Drainage Submission (Revised) in support of

Planning Application No. A/YL-TT/523

(HT21105)

CE/MN, DSD's Comments issued under PlanD's Letter dated 24 December 2021	Responses
<p>(i) The existing drainage facilities, to which the stormwater of the development from the subject site would discharge, are not maintained by this office. The applicant should identify the owner of the existing drainage facilities to which the proposed connection will be made and obtain consent from the owner prior to commencement of the proposal works. In the case that it is a local village drains, DO/YL should be consulted.</p>	<p>DO/YL has confirmed no objection to the proposed drainage connection. A copy of the email of DO/YL dated 7/2/22 is enclosed in the revised Drainage Submission.</p>
<p>(ii) The applicant should check and ensure the hydraulic capacity of the existing drainage facilities would not be adversely affected by the captioned development.</p>	<p>The sizes of the channels of the subject site are in accordance with the "Technical Note to prepare a Drainage Submission (relating to application for temporary change of land use such as temporary storage areas, car parks, workshops, small fact

SKETCH A

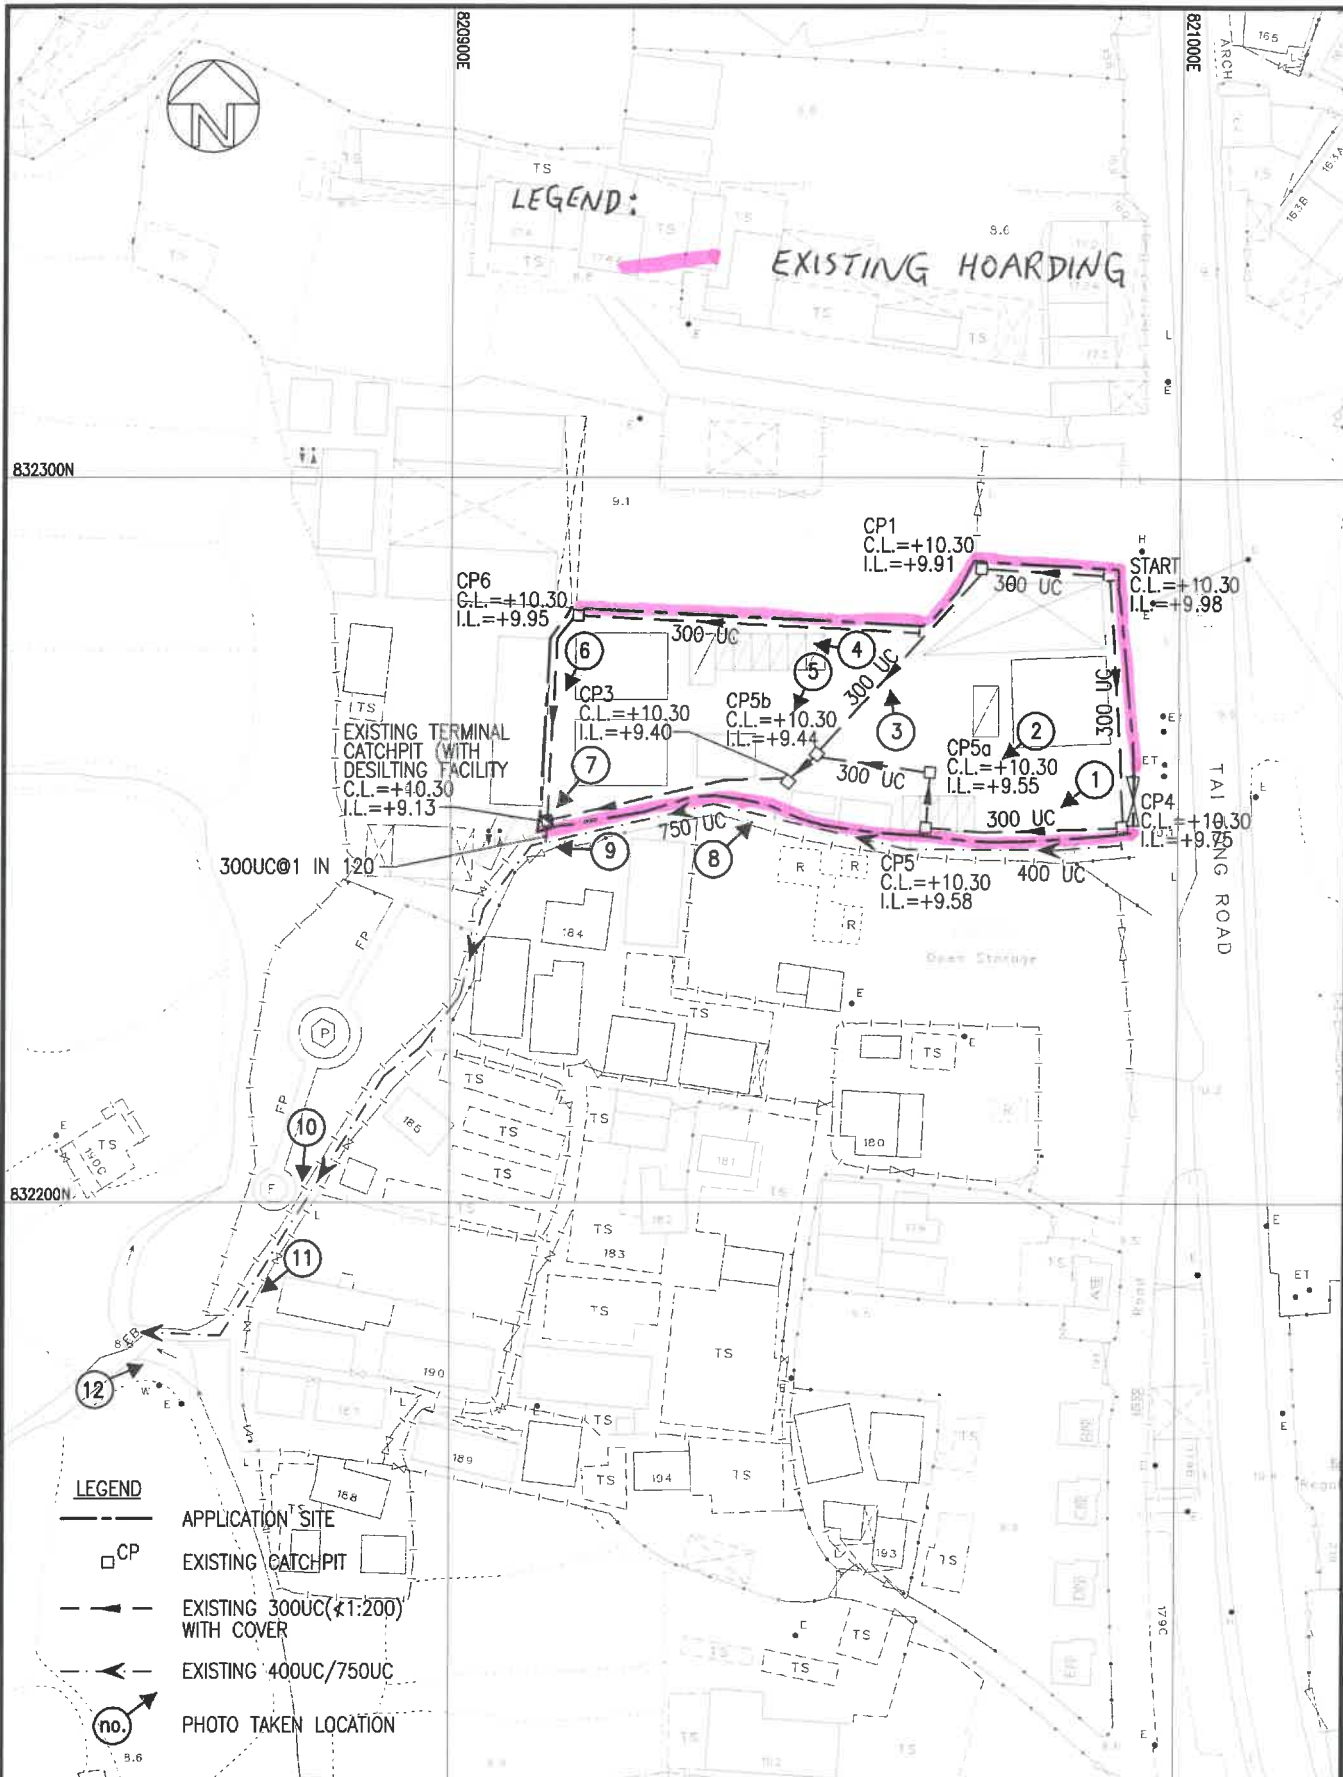
<p>(iii) The location and details (i.e. cross section) of the proposed hoarding/peripheral wall should be shown on the proposed drainage plan. Please be reminded that overland flow from adjacent area should not be obstructed.</p>	<p>The subject site is bounded by hoarding at three sides, i.e. the eastern, southern and northern boundary, as indicated in the attached Sketch A. A photo showing typical details of the hoarding is attached below:</p>

CE/MN, DSD's Comments issued under PlanD's Letter dated 24 December 2021	Responses
	 <p data-bbox="1104 783 2045 943">There is no hoarding along the western boundary of the subject site, but there is an existing building on the adjacent lot abutting upon the boundary (please refer to the photo in the below). Surface runoff across the western boundary into the subject site can be ignored.</p>

CE/MN, DSD's Comments issued under PlanD's Letter dated 24 December 2021	Responses						
	<p>At present, outside all the three sides of the subject site bounded by the hoarding are surface channels/gullies to receive surface runoff and therefore surface runoff from the adjacent areas would not flow across the boundary into the subject site. Current conditions are shown in the photos below:</p> <table border="1" data-bbox="1108 579 2040 967"> <tr> <td data-bbox="1108 579 1413 794">  </td> <td data-bbox="1413 579 1727 794">  </td> <td data-bbox="1727 579 2040 794">  </td> </tr> <tr> <td data-bbox="1108 794 1413 967"> Outside the southern boundary (gullies/water inlets exist) </td> <td data-bbox="1413 794 1727 967"> Outside the eastern boundary (gullies exist) </td> <td data-bbox="1727 794 2040 967"> Outside the northern boundary (surface channel exists) </td> </tr> </table>				Outside the southern boundary (gullies/water inlets exist)	Outside the eastern boundary (gullies exist)	Outside the northern boundary (surface channel exists)

Plate 8 – Existing 750mm U channel receiving discharges from the subject site and running outside the southern subject site boundary

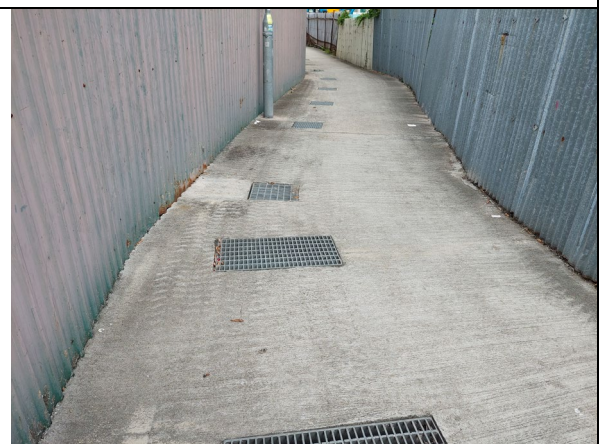
I refer to your preceding email and our telephone conversation this afternoon. Please be informed that the concerned channels as shown on Plate 8 to Plate 11 are maintained by Yuen Long District Office. This office has no comment to the proposed connection provided that the proposed works would not cause any adverse drainage impacts to the surrounding areas from maintenance point of view.
